UPDATED URGENT FIELD SAFETY NOTICE – FSN-33718-2

PRODUCT	REF	Software Versions
UniCel DxH 800 Coulter Cellular Analysis System	629029, B24465, B24802, B68304, B66445, B63322	All
UniCel DxH 600 Coulter Cellular Analysis System	B23858	All
UniCel DxH 900 Coulter Cellular Analysis System	C11478	All

This notification replaces our previous urgent Field Safety Notice Letter dated August 10, 2018 concerning sporadic erroneously elevated platelet results. Beckman Coulter is initiating a field action for the products listed above. This letter contains important information that needs your immediate attention. Patient results may be affected. No death or serious injury has ever been reported in association with this issue.

Figure 1 Sweep flow schematic. $Q1/Q2/Q3$ are 96 inches of low diameter tubing. Air is injected into the system when one of the lines has air pushed past to the Y1/Y2 fittings from the clearing process originating at F1,2,3.

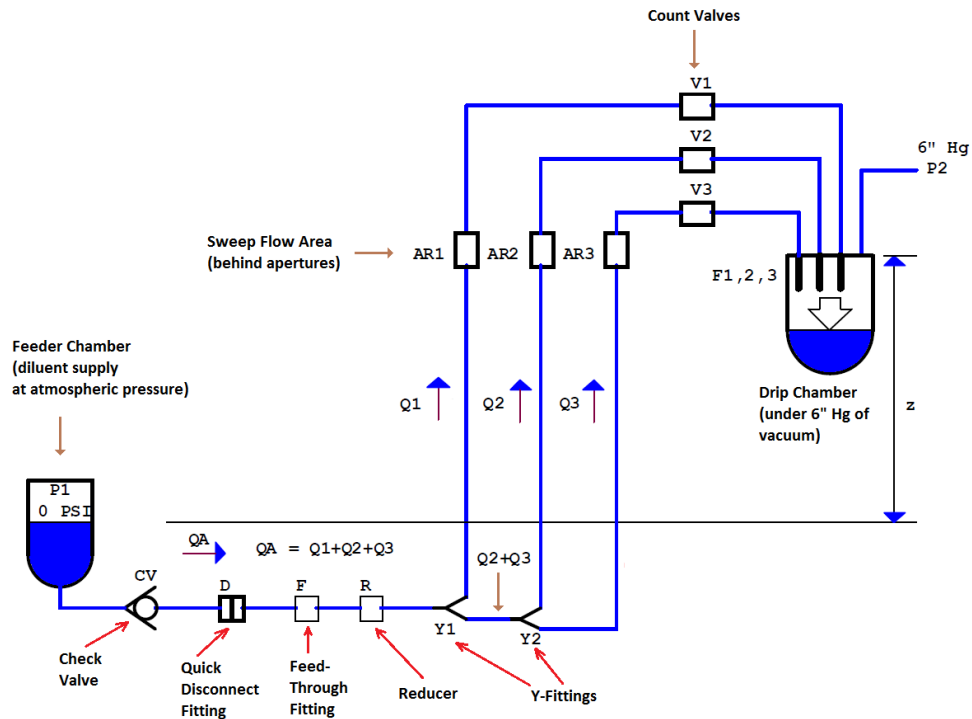
<p>ACTION:</p>	<ul style="list-style-type: none"> • Ongoing investigation indicates that the probable root cause is the sweep flow disruption that may occur following the “Clear RBC Apertures” procedure. This potential root cause is currently under further investigation. Customers should discontinue using this procedure. • If you suspect that your instrument has a clogged aperture that will not clear, discontinue use of the analyzer and contact your local Beckman Coulter representative for further assistance. • Use the following quality control measures to aid in identification of discrepant platelet results: <ul style="list-style-type: none"> ○ Follow your laboratory’s standard operating procedure to confirm unexpected results. ○ Repeat testing of samples in a workflow configuration may facilitate the identification of discrepancies. ○ Additional instrument and/or LIS features including reference ranges, XM (exponentially-weighted moving average) and delta checks may be informative. • Consult with your Medical Director to determine if a retrospective review of results is warranted. • Report any unflagged erroneously elevated platelet counts experienced in your laboratory to your local Beckman Coulter representative.

<p>RESOLUTION:</p>	<ul style="list-style-type: none"> • To detect and flag erroneously elevated platelets due to temporary disturbance of the sweep flow, Beckman Coulter implemented an algorithm improvement. This algorithm improvement was implemented by way of one of the following: <ul style="list-style-type: none"> • Software upgrades, DxH 800 version 3.2.1 and above and DxH 600 version 1.3.1 and above. • Customer-installable software patch made available in October 2018 • Software version 1.0.0 and above for DxH 900 • If your DxH 800 / DxH 600 system has not yet been upgraded with the improved algorithm, please contact your local Beckman Coulter representative. All fielded DxH 900 analyzers have the improved algorithm incorporated into their original software. • Beckman Coulter continues to investigate the unflagged elevated platelets issue and assess the “Clear RBC Apertures procedure” as well as other potential root and/or contributing causes.

Figure 2 (Top) Oscilloscope capture of a pulse believed to be a recirculating RBC; (Bottom) Oscilloscope capture of a normal platelet. Note the difference in FWHM.

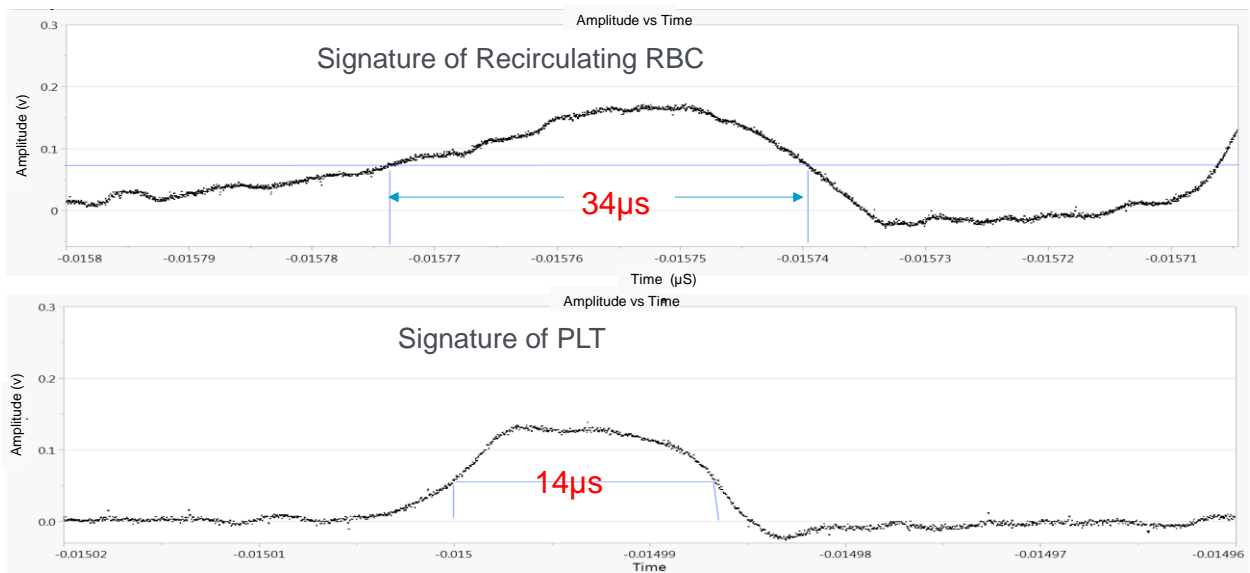
ISSUE:	As reported in our Field Safety Notice Letter dated August 10, 2018, Beckman Coulter has confirmed complaints of erroneously elevated platelet results with rare occurrences, without flags or system messages. The underlying issue is temporary disturbance of the sweep flow. Preliminary root cause investigation indicates that sweep flow disruption may occur following the Clear RBC Apertures procedure. The issue may affect one or multiple samples tested in sequence. Beckman Coulter has not received complaints of this issue impacting the other reported parameters: HGB, WBC Count, WBC Differential, or RBC results. There have been no reports of this issue on the DxH 900.
IMPACT:	<ul style="list-style-type: none"> • Thrombocytopenia may go unrecognized. • Patients at high risk include those with malignancies (including those with iatrogenic thrombocytopenia), heparin-induced thrombocytopenia, thrombotic microangiopathic anemia, immune thrombocytopenic purpura and thrombocytopenia associated with pre-eclampsia. • The reported magnitude of error ranges from 33×10^3 cells/μL to 990×10^3 cells/μL based on reported complaints. • No additional complaints have been received for this issue on any system with the improved flagging algorithm which is able to generate an R flag message (PLT-Int) in cases with erroneously elevated platelet results.
